East Lancashire Paper Mill, Radcliffe

Highways Response

Client:	Morris Homes	Job No:	327112
Date:	08 July 2024	File Name:	TN02
Prepared by:	LJ	Approved by:	ME

Figure 3.1 : Visibility Splays for Access under Plot 136 & 205

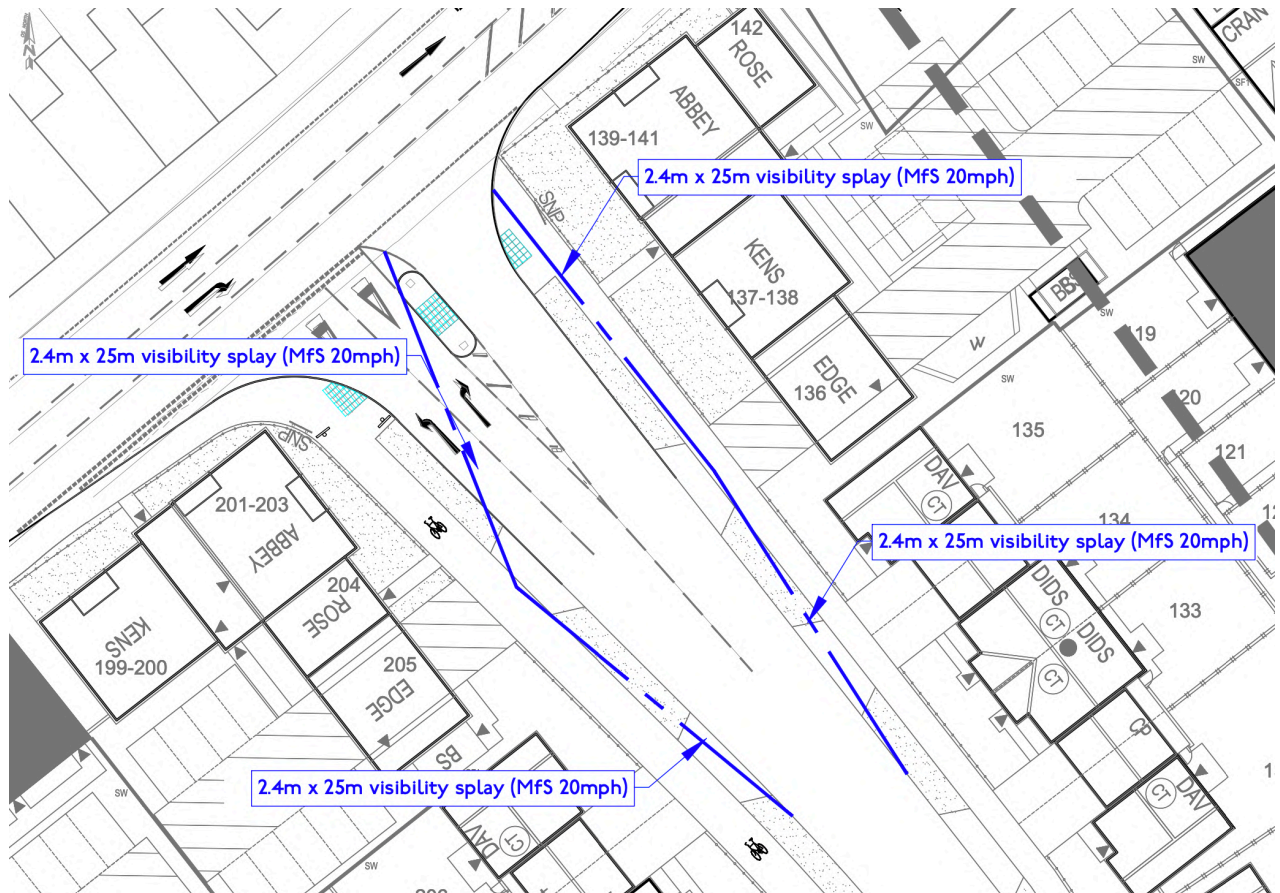
"The accesses under Plots 136 & 205 are located too close to the Cross Lane junction and would conflict with right turn queuing traffic and the proposed hatching, and therefore need to be reconsidered."

- 3.2.1 For the design speed of 20mph, the required visibility splays of 2.4m x 25m in accordance with Manual for Streets (MfS) can be achieved. The required visibility splays are shown in [Figure 3.1](#) and attached in **Drawing J32-7122-PS-004** attached in [Appendix A](#).

3.2.2 Furthermore, the extremity of the splays towards the Cross Lane Access are close to the junction where it is likely that vehicles will be travelling below the design speed of 20mph, thereby making the achievable visibility splays more than adequate and preventing any concerns with regards to highways safety.
